**MAJOR PROJECT ASSESSMENT:  
Section 75W Modification  
6 -16 Atchison Street, St Leonards  
(09\_0187 MOD 2)**

Director-General's  
Environmental Assessment Report  
Section 75W of the  
*Environmental Planning and Assessment Act 1979*

February 2014

Figure 4: Proposed Basement level 1 as per the traffic expert's recommendations

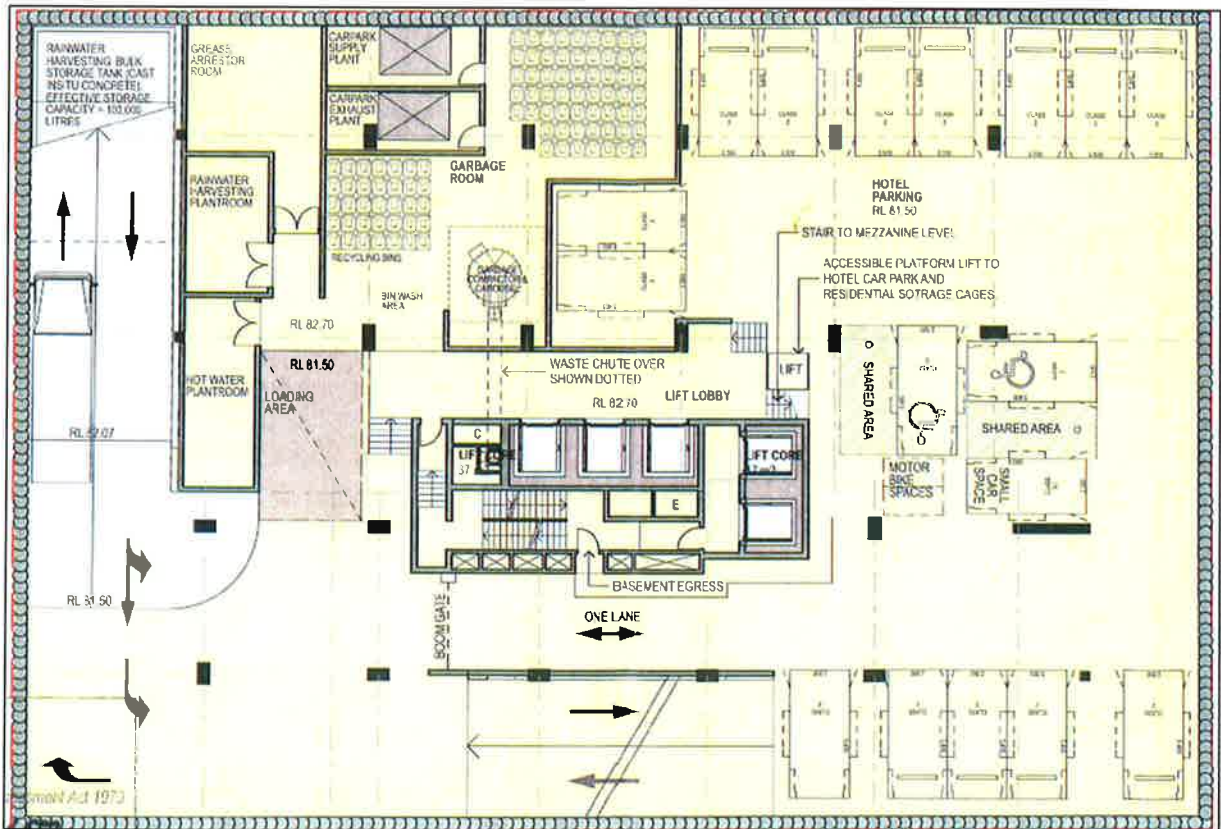
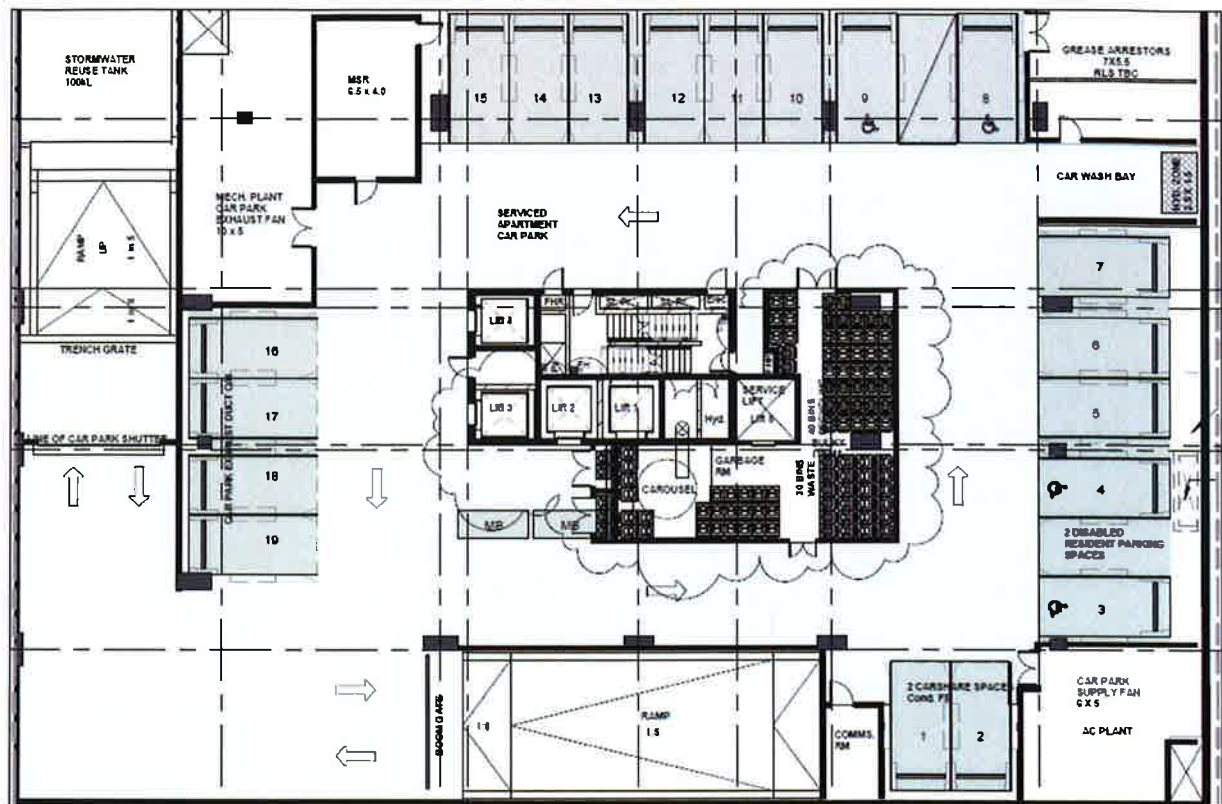
The application seeks to retain the basement servicing and access as per the Project Approval (**Figure 3**). The vehicular entry point, circulation areas and clearance of the basement levels are proposed to be modified (**Figure 4**). Consequently, the building services have been adjusted to accommodate the revised garbage storage and collection arrangement. This includes adjusting the public domain area RL to allow for the required height clearance.

The agency engaged ARUP, an independent traffic expert, to review the proposed basement layout and provide an assessment of the proponent's justification for an at-grade loading dock on Atchison Lane (as proposed in the application as lodged). ARUP concluded that the basement ramp could be redesigned (to accommodate a Council garbage vehicle to a 3.6 m height clearance). This would significantly reduce the length of the ramp and associated loss of ground level public domain compared with the application as lodged, and is similar to the approved scheme.

The response to submissions incorporates the recommendations of the agency's traffic expert who confirmed the design complies with the Australian Standards, and is satisfactory in terms of internal manoeuvrability and ramp design subject to a minor amendment to ensure adequate vertical headroom clearance (at points 1 and 2 in **Figure 5**). This is reflected in the recommended modification instrument. The agency supports the application and recommends the Project Approval be modified in accordance with the traffic expert's recommendations.
